Clause 33 MPS Fix: A Simple State Diagram Approach

Texas Instruments

March 2019

Figure 33–10—PSE monitor inrush and monitor MPS state diagrams

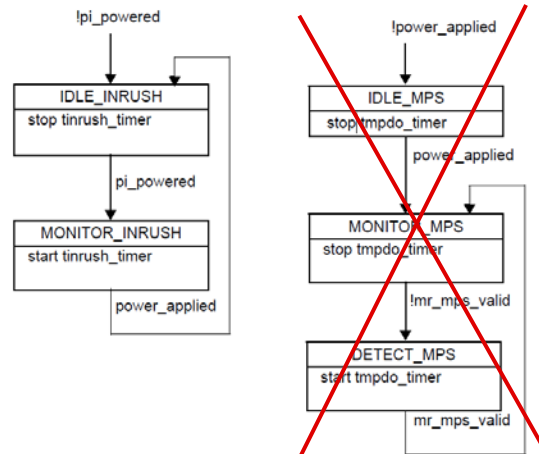
- Remove MPS portion of Figure 33-10 (current the Inrush and MPS state diagram)
 - Rename Figure 33-10 to “PSE monitor inrush state diagram”
